Determination 2016/024

The refusal to issue a code compliance certificate for a 21-year-old house with corrugated steel wall cladding at 16 Rotoiti Street, Dunedin

Figure 2: The house

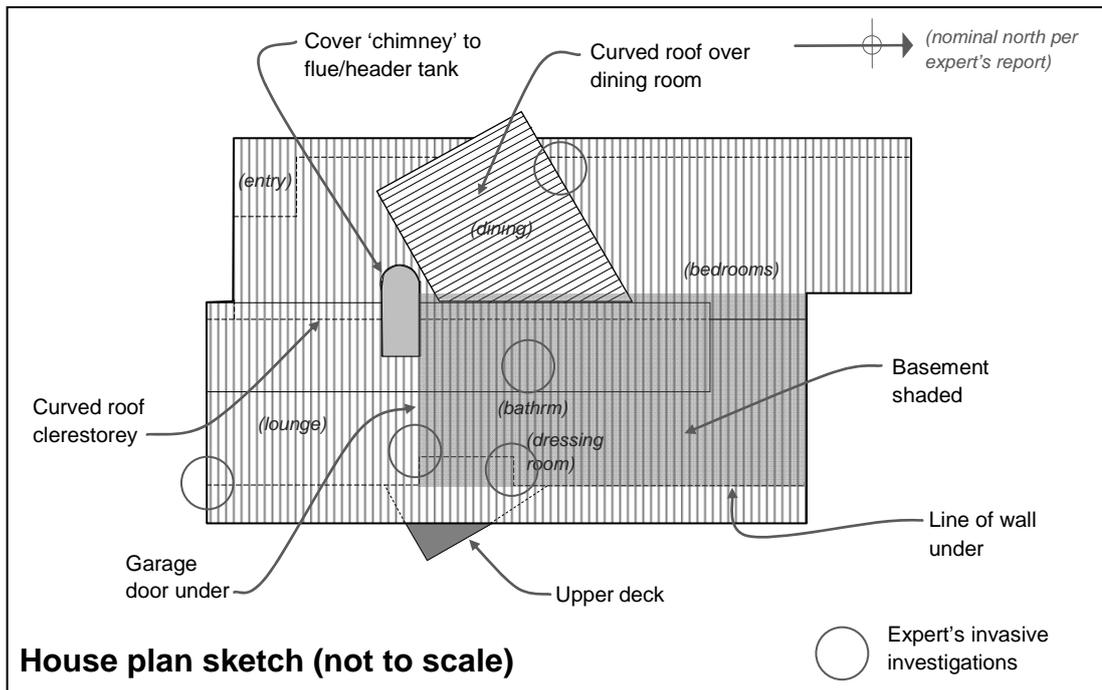
- 2.2 The house accommodates living areas, three bedrooms and an office in the upper level, with a fourth bedroom and a garage in the partial basement. A small upper deck, with a membrane floor and open timber balustrades, extends from recessed sliding doors in the east wall of the lounge, with part of the deck situated above the basement garage below and the remainder cantilevered beyond the basement wall as shown in Figure 2 (over page).

- 2.4 The roof is a mix of gables and monopitch roofs as shown in Figure 2, with eaves generally greater than 600mm overall, no verge overhangs and a raised curved section above the ridge to provide west-facing clerestory windows. A separate curved section to the west is raised above the living room and oriented at an angle to the main roof. The latter roof extends out as an angled projection beyond the west wall line, with full height glazing curved at the top in line with the roof.

- 5.4.6 The upper deck extends from recessed sliding doors in the east wall of the lounge, with part of the deck situated above the unlined basement garage below. Floor joists cantilever beyond the basement wall at the same level as the interior floor level, with liquid-applied membrane (“LAM”) applied over a plywood substrate.

- 5.4.7 The membrane turns down the boundary joist at the edge of the deck, with balusters side-fixed through the membrane into the joist. The timber handrail is fixed against a timber window mullion at the south end and through the cladding at the north end.

- 5.4.8 A 50mm timber door threshold forms an upstand, covered with a metal flashing sealed against the deck membrane. The wall cladding also butts against the membrane with sealant applied at the junction. The boundary joist penetrates the cladding, with no saddle flashing and sealant applied for weatherproofing.
